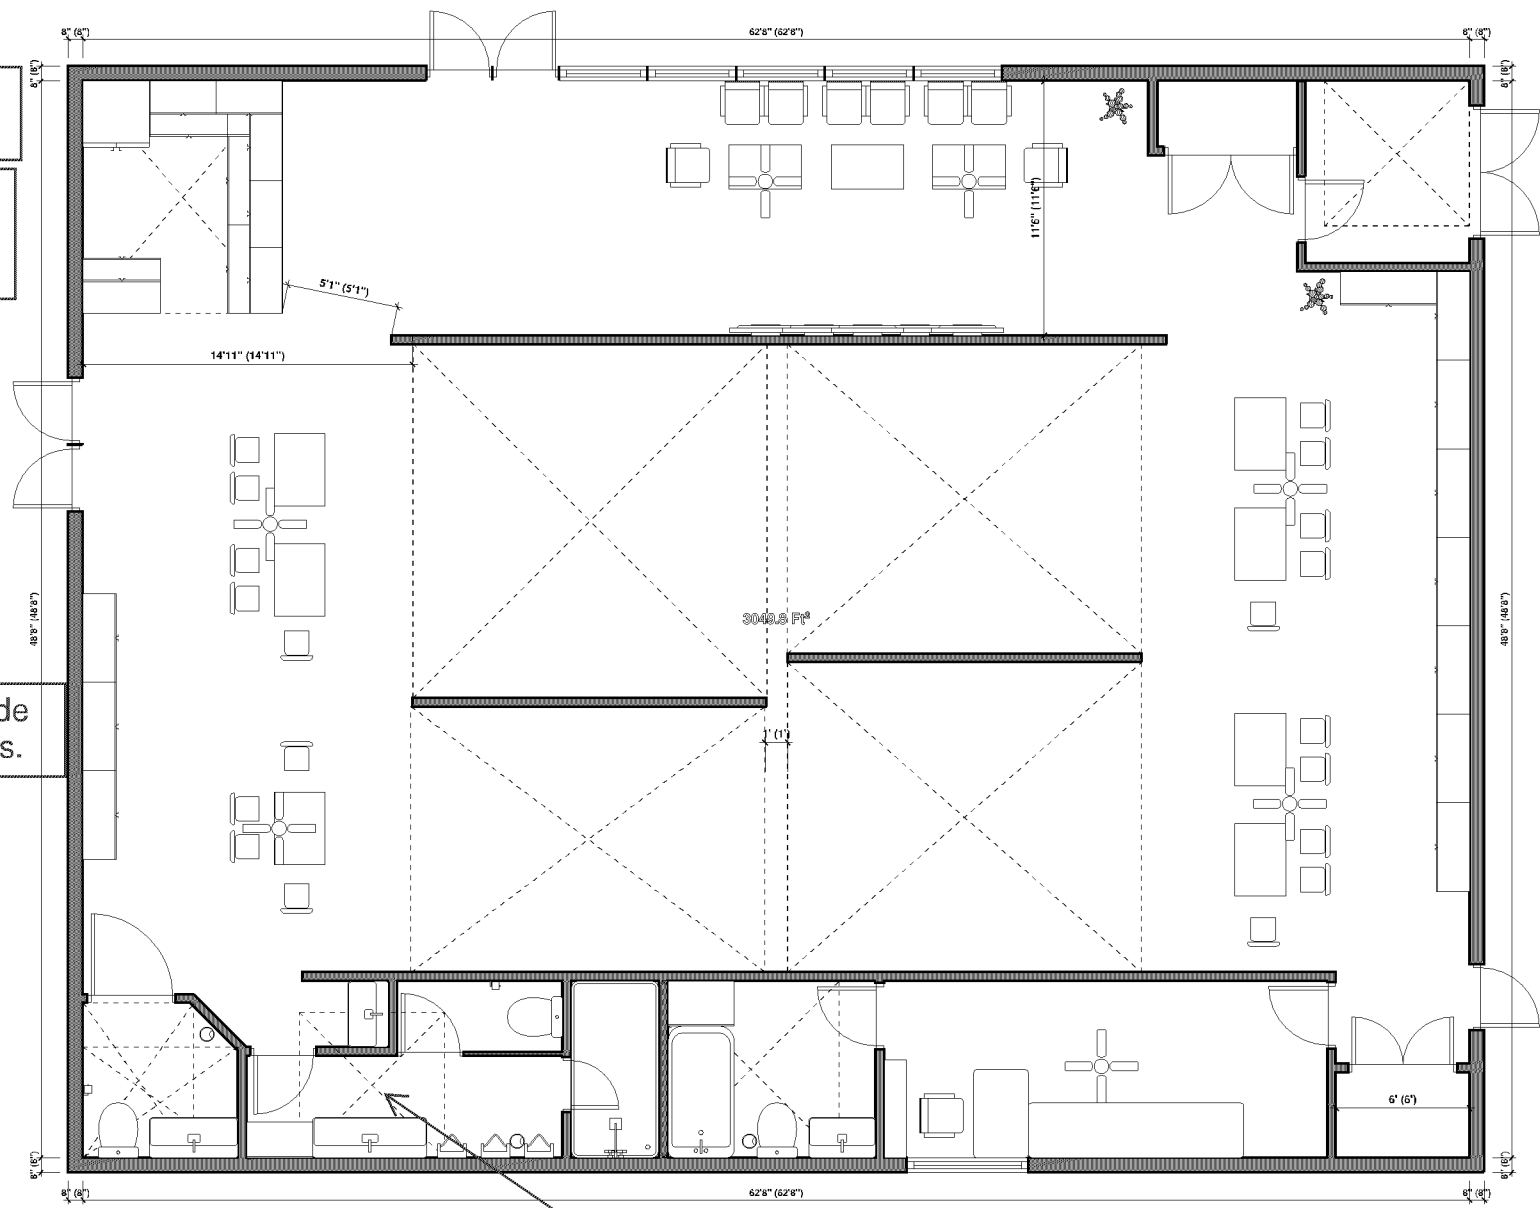
All exterior doors that allow access to the interior of the building(s) shall be numbered in a sequential order starting with the main entrance (public entrance) as number 1 and continue in a clockwise manner.

Ensure landscaping doesn't interfere with access to the building, hydrants and/or FDC.

Provide an Environmental Health Plan Review application with plan submittal for each proposed food facility.

Fire alarm, annunciator panels and Knox box locations to be determined by the Fire Prevention Division.

Entire space to have a code compliant sprinkler system.

Must meet 2020 MN State Building Code

Building plans must be signed by a MN licensed architect.

SAC review by MET council will be required.

Must meet 2020 MN Accessibility Code.

Provide a detailed code analysis with the plans.

Provide specification sheets during plan submittal on all new and used equipment being proposed for use in this facility.

Must meet fixture count per Chapter 29 of 2020 MN Building Code.

Provide description of proposed food service operations. Provide location, equipment, menu and storage area locations and finishes.

Include plan for exterior, parking lot and circulation modifications in next submittal.
